IN THE UNITED STATES PATENT AND TRADEMARK OFFICE

For: SEMICONDUCTOR DEVICE AND

METHOD FOR MANUFACTURING SAME

PRELIMINARY AMENDMENT

FIG. 8

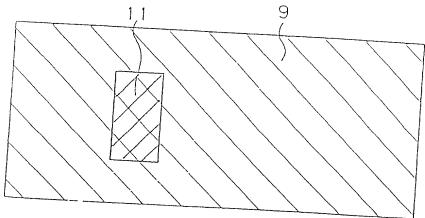
Next, an Au plating is applied to the heat sink, and the heat sink Au plating package is then bonded to the active element. As shown in figures 8 and 9 the Au plating (11) has distinctive boundaries. The Au plating is not shown as contacting the aluminum nitride, nor is the plating shown as expanding beyond the surface of the source electrode which it covers. Additionally, in Figure 8 of the application there is an overheard view of the package where the gold plating is shown as approximately the same width as the source electrode which it will have to cover. Accordingly, if the Au plating is approximately the same width

FIG. 9

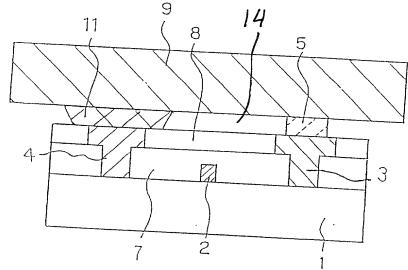
-- The active element and the package, prepared as described above, are positioned so that the source electrode 4 of the active element faces/abuts to the Au plating 11 on the heat sink 9 of the package, and the active element and the package are bonded to each other by thermal pressure bonding for mounting, leaving a void 14 between the Au plating 11 and the Aluminum nitride 5, as show in Fig. 9.--

--The active element and the package, prepared as described above, are positioned so that the source electrode 4 of the active element faces the Au plating 11 on the heat sink 9 of the package, and so that the drain electrode 3 faces the aluminum nitride 5, leaving a void 14 between the Au plating and the aluminum nitride 5. In this state, the active element and the package are bonded to each other by thermal pressure bonding for mounting, as shown in Fig. 9. –

The "void" which is the basis for the amendments to the claims and the specification, is formed by a space between the Au conductor, which covers the source electrode and the aluminum nitride insulator, which covers the drain electrode. On page 13 of the specification the steps for forming the aluminum nitride insulator on the drain electrode of the active element are recited. Initially, the second insulating layer is etched back to expose the source and drain electrodes. Then aluminum nitride is deposited over the entire chip. The aluminum nitride is then etched so that it only covers the drain electrode. Subsequently there are no further insulating layers deposited on the active element.

Please approve the changes to figures 9 and 11 of the attached drawings (2
